UNITED STATES PATENT AND TRADEMARK OFFICE

10/597,158

Office Action Summary	Application No. 10/597,158	Applicant(s) WAGENER ET AL.	
	Examiner JEFFREY ALLEN	Art Unit 3781

DETAILED ACTION

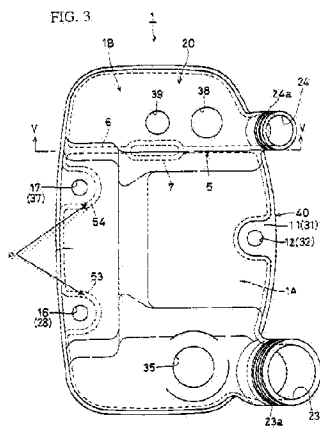
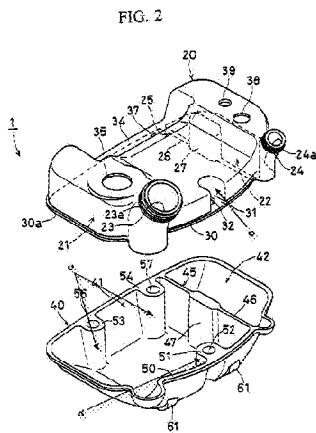
10. Regarding claims 1-6 and 8, Yokochi discloses a tank for oils or liquids comprising a tank part (1) having a tank volume, a fastening means (81) made up of a screw connections that pass through the tank volume in a leak proof manner, ducts (d, Fig. 2 below labeled by examiner) extending within the tank part on an outer circumference of the tank part that screws extend through, a tank cover (col. 4, lines 16-18), a filler neck (23) and two connection pipes (73 and 76). The ducts are shortened in relation to the depth of the tank and recesses are provided on the circumference of the tank, this creating a space between the ducts and the tank cover (Fig. 4). The screws are premounted on the tank prior to use and the tank further providing positioning aides (p) located on an outer surface of the tank part in an area of first and second ducts.
